Well Name: JAMES RANCH UNIT APACHE	Well Location: T22S / R30E / SEC 13 / SESE / 32.386074 / -103.828703	County or Parish/State: EDDY / NM
Well Number: 802H	Type of Well: OIL WELL	Allottee or Tribe Name:
Lease Number: NMNM89051	Unit or CA Name:	Unit or CA Number:
US Well Number: 3001555782	Operator: XTO PERMIAN OPERATING LLC

Type of Action: APD Change

Procedure Description: XTO Permian Operating, LLC. respectfully requests approval to make changes to the drilling program in the approved APD & requests permission for a primary and a contingency drilling program for this well. Primary will be a 4-string design with an engineered weak point (R-111-Q: Figure F) & the contingency will be a 3-string design with an open production casing annulus (R-111-Q: Figure B). See attached drilling program for the primary & contingency design with updated casing design, cement program & mud circulation system. There will be no new surface disturbance.

JAMES RANCH UNIT APACHE 802H
Projected TD: 19960' MD / 9698' TVD
SHL: 446' FSL & 963' FEL , Section 13, T22S, R30E
BHL: 1832' FSL & 50' FWL , Section 14, T22S, R30E
EDDY County, NM

[Figure F] 4 String – 2nd Intermediate casing engineered weak point

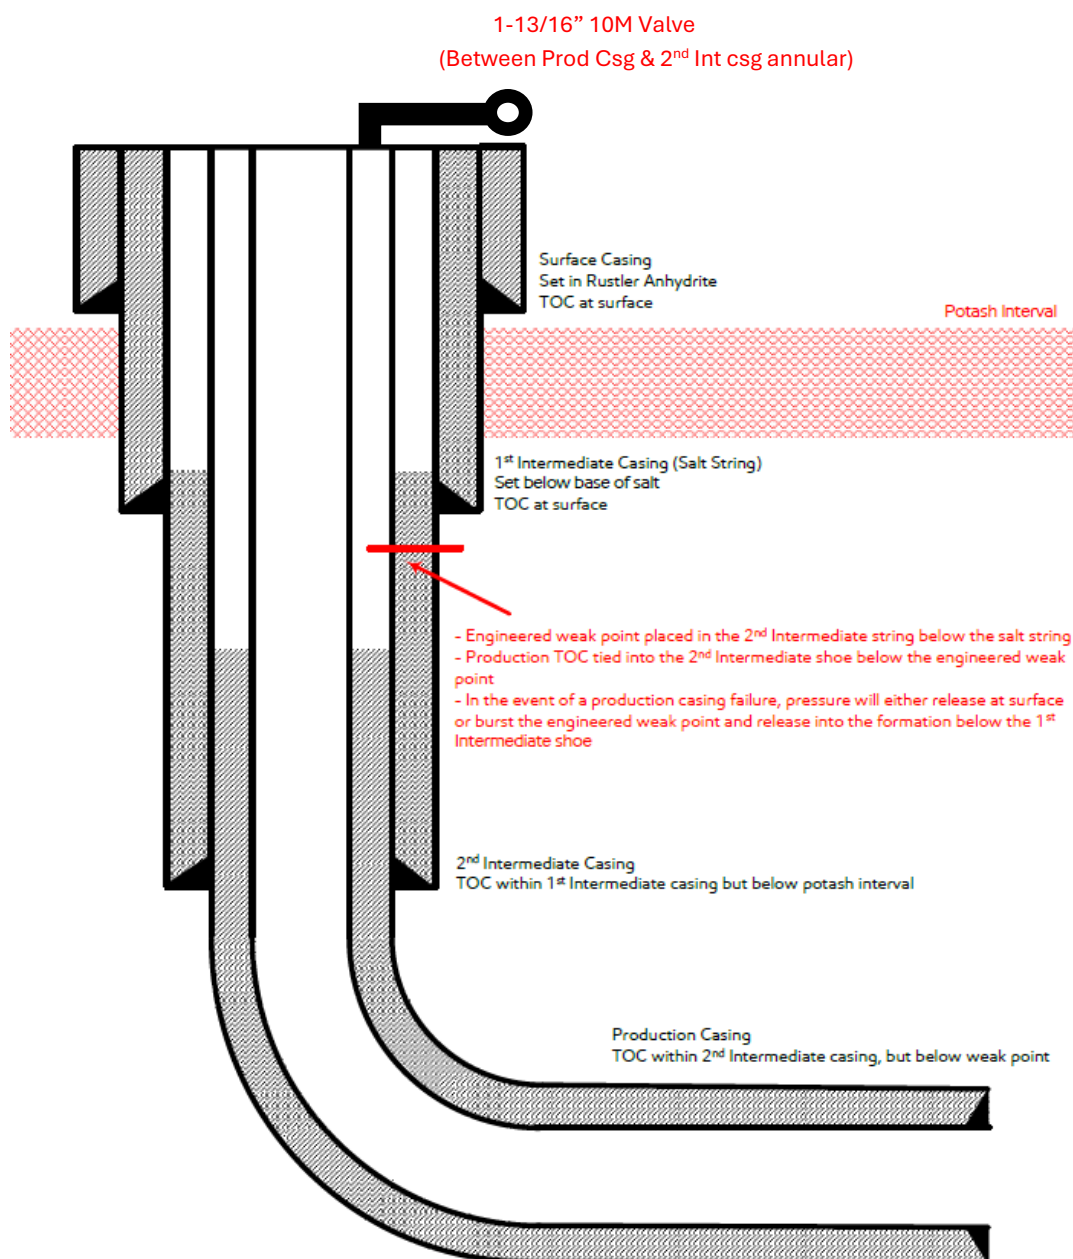
Update May 2024:

XTO is aware of R-111-Q update and will comply with these requirements including (but not limited to):

- 1) Alignment with KPLA requirements per schematic below, with engineering weak point casing design and utilizing new casing that meets API standards.
- 2) Contingency plans in place to divert fluids away from salt interval in event of production casing failure.
- 3) Intermediate 2 casing will consist of a primary cement job with TOC at the top of the Brushy Canyon formation within the Delaware Mountain Group.
 - a. Bradenhead squeeze to be completed after primary cement job to tie back TOC to intermediate 1 "Salt string" & below Marker Bed 126 "Potash Interval".
- 4) Production cement to be tied back no less than 500' inside previous casing shoe (intermediate 2 casing) and below the engineered weak point.

Figure B – 3 String Design – Open Production Casing Annulus (Updated May 2024):

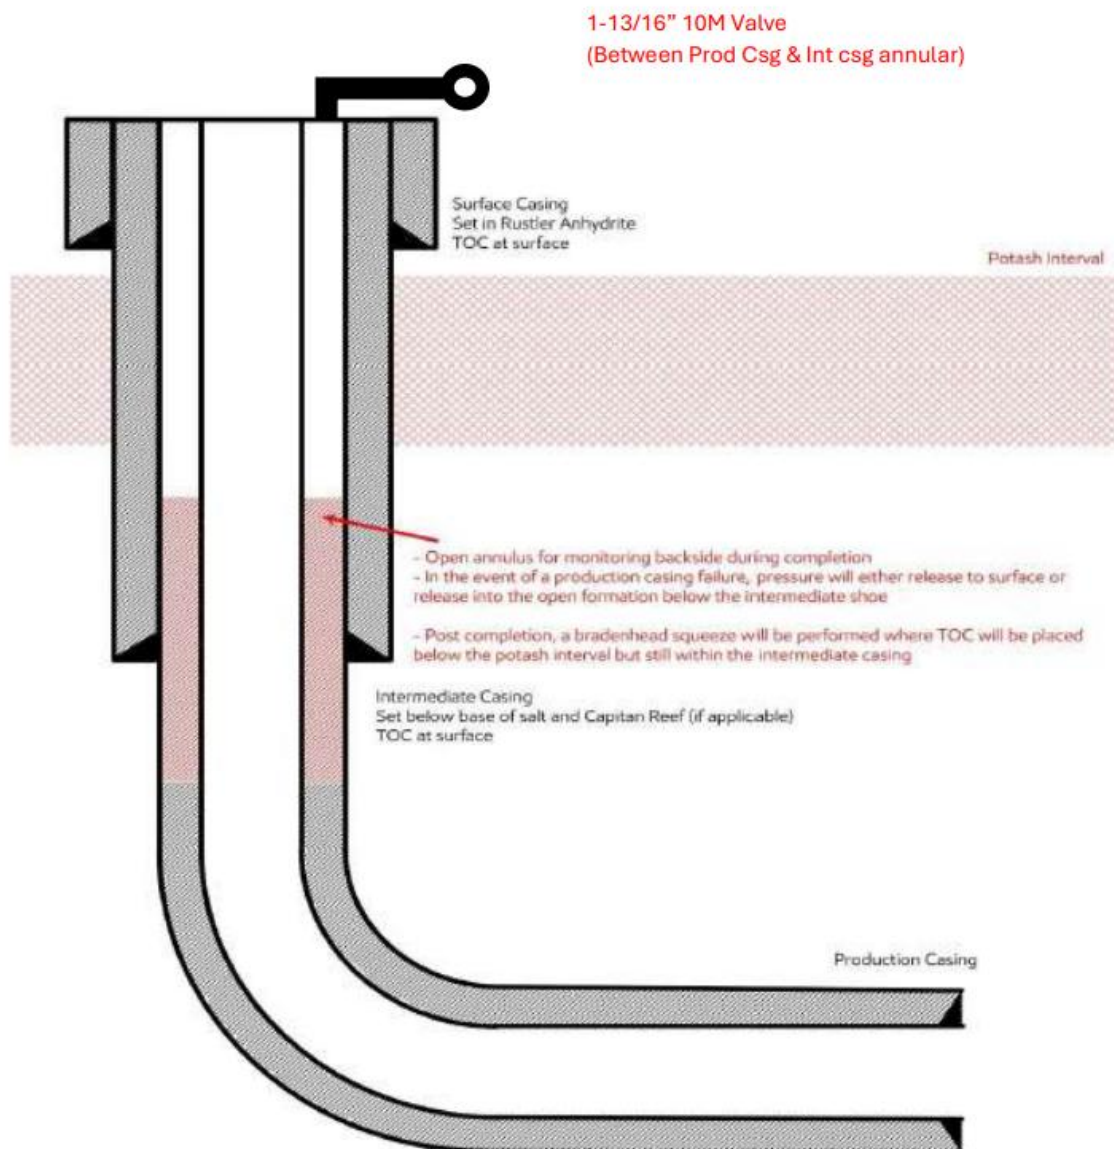
XTO is aware of the R-111-Q update & will comply with these requirements including (but not limited to):

1. Alignment with KPLA requirements per schematic above, leaving open annulus for pressure monitoring during frac and utilizing new casing that meets API standards
2. Contingency plans in place to divert formation fluids away from salt interval in event of production casing failure
3. TOC in the annulus between intermediate & production casing string shall stand uncemented at least 500 feet below the intermediate casing shoe
4. Bradenhead squeeze to be completed within 180 days after hydraulic frac operations have been concluded to ensure at least a 500 feet tie-back has been established inside salt string but with top below MB 126
